DA Form 1 – Development application details

We refer to Douglas Shire Council's (Council) Decision Notice MCUC 2023_5563/1 (DN) dated 24 April 2024 for 12 Murphy Street and MCUC 2022_4732/1 dated 7 October 2022. Applin Consulting has been engaged to document the civil Operational Works (OW) plans associated across both properties and to submit and compile a response to Council's conditions which are relevant to the shared driveway referenced in MCUC 2023_5563/1.

CULLEN-BIDDLE RESIDENCE

12 MURPHY STREET (LOT 113 PTD2094), PORT DOUGLAS

LONGITUDINAL SECTION - DRIVEWAY CL01

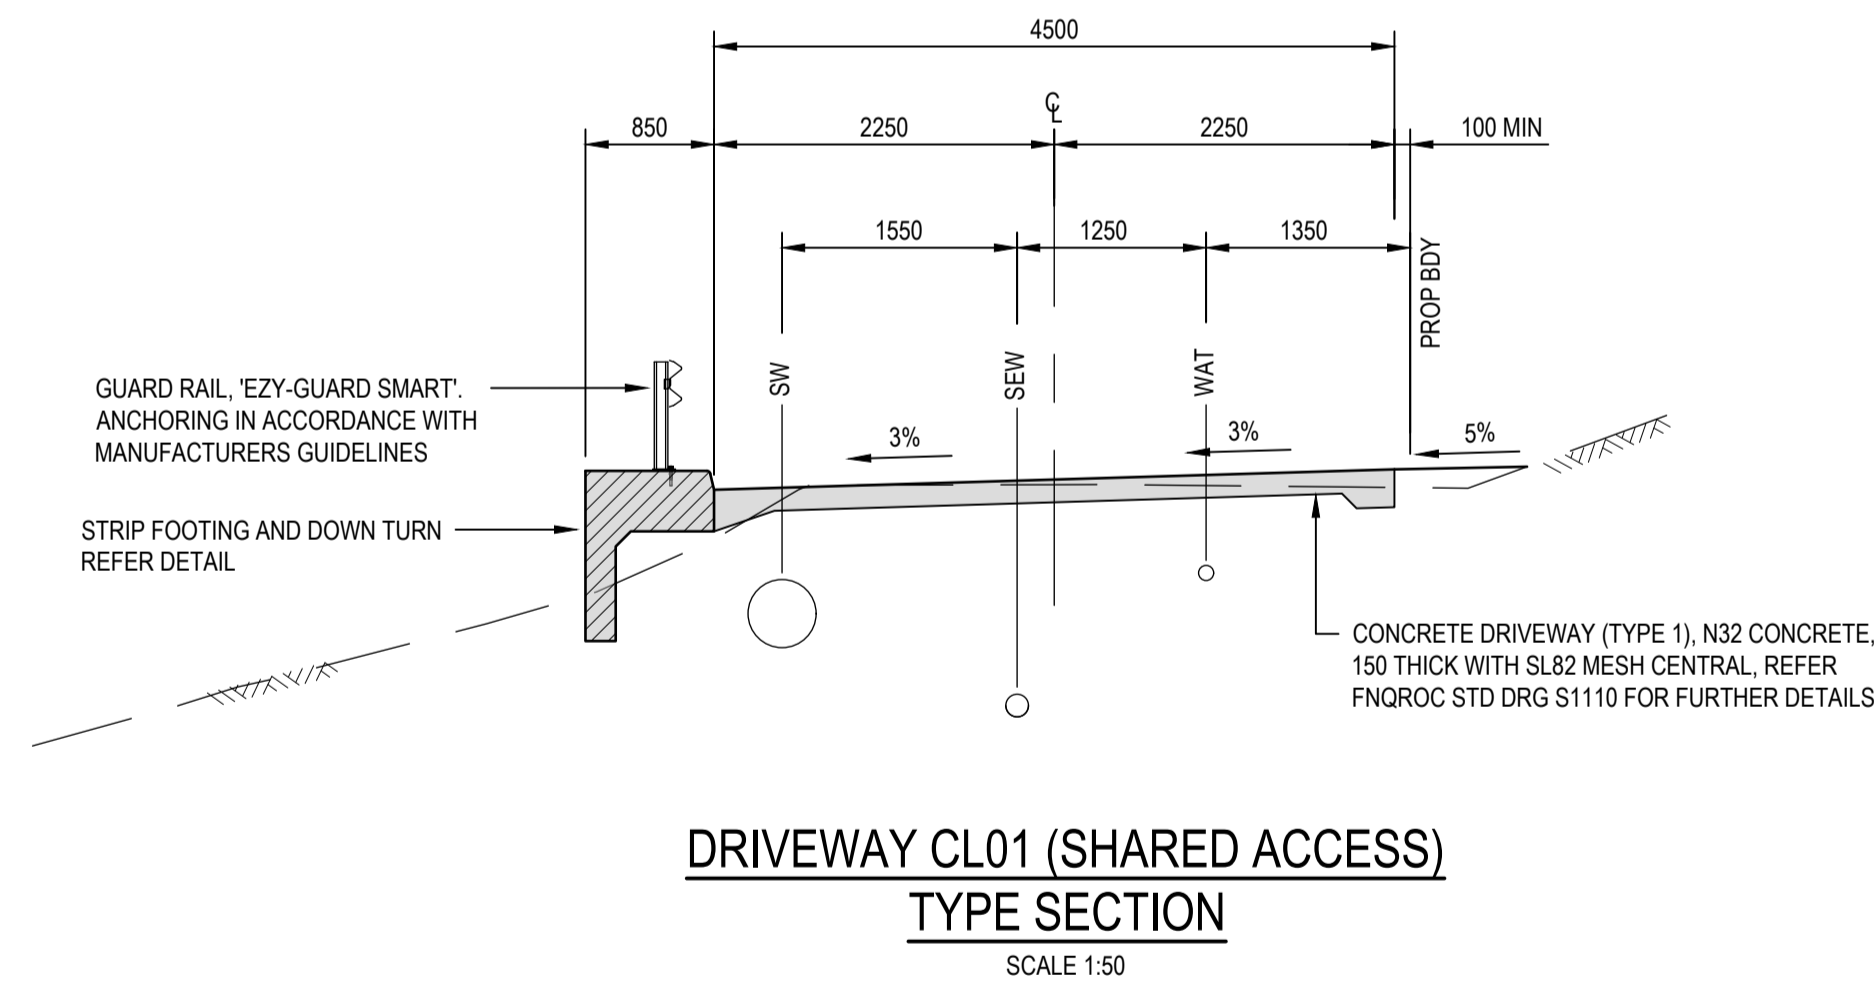
6. Revise the grade of the Shared Access Driveway to achieve a minimum grade of 0.3% between Chainage 40.0m to 64.444m to aid the conveyance of stormwater to Murphy Street. Amendment to the shared access driveway design must be provided to the satisfaction of the Chief Executive Officer prior to the issue of a Development Permit for Operational Works.

BATTER CHUTE
SCALE 1:50

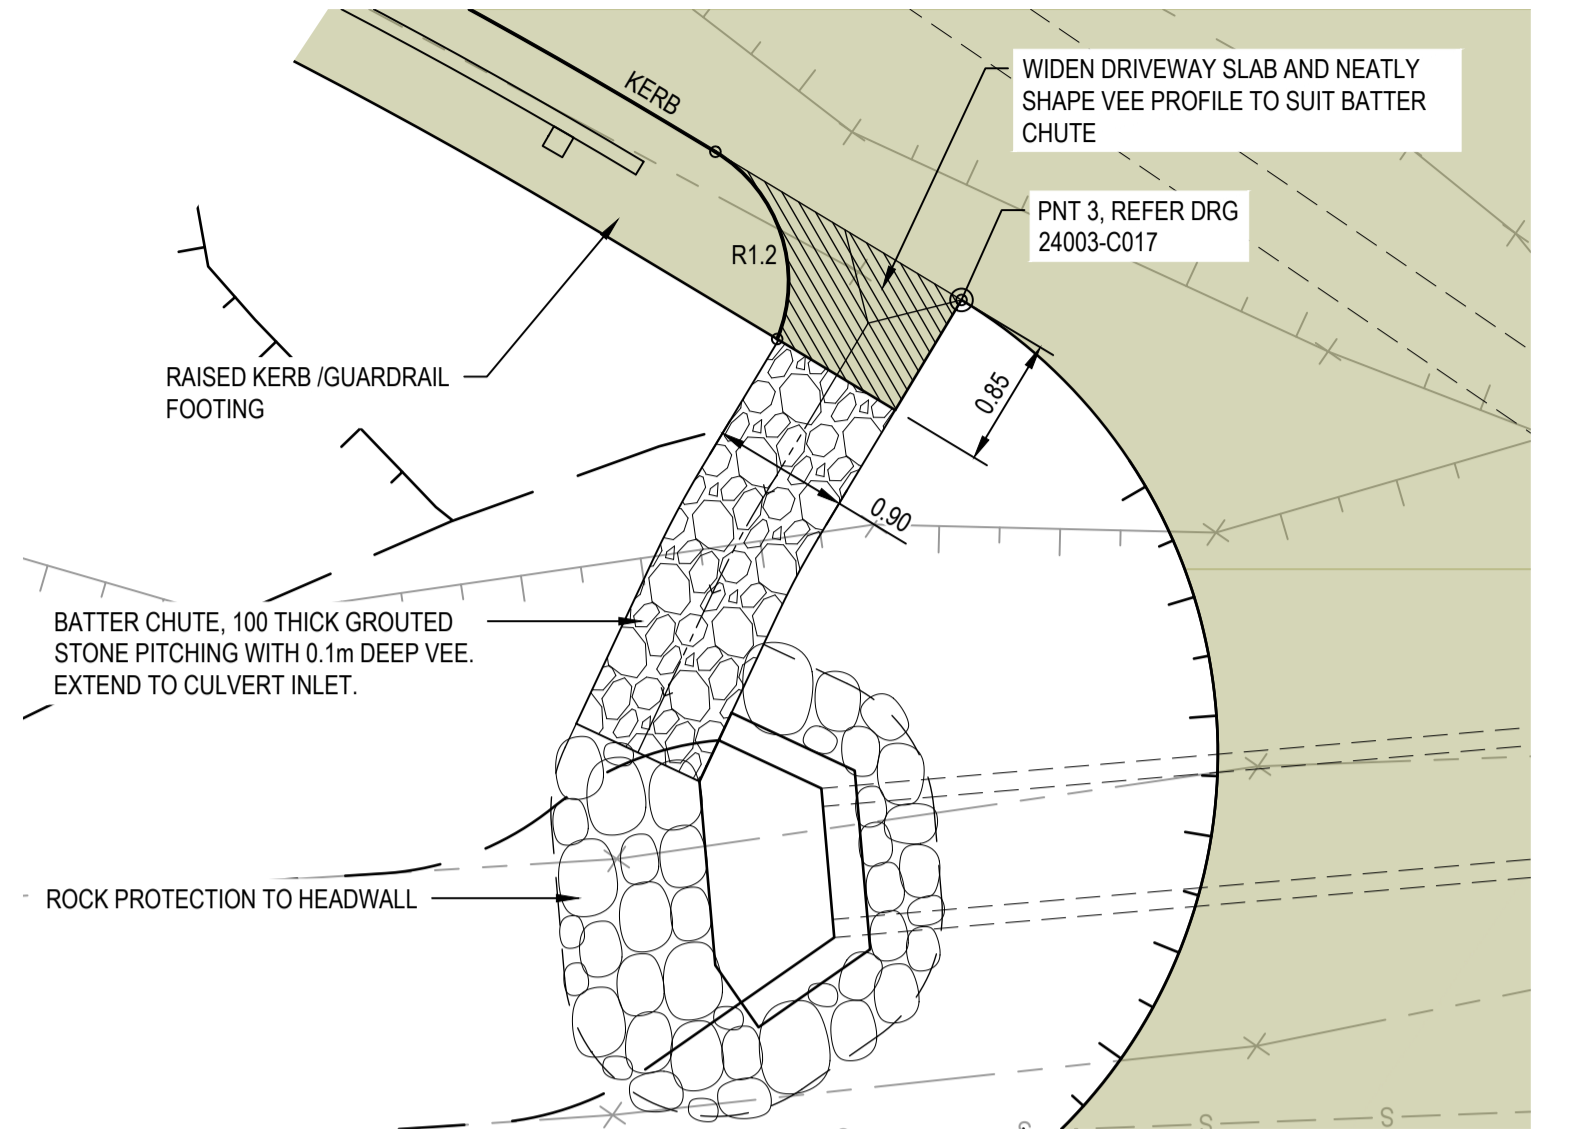
Batter chute added. Refer detail below from drawing 24003-C018 (B).
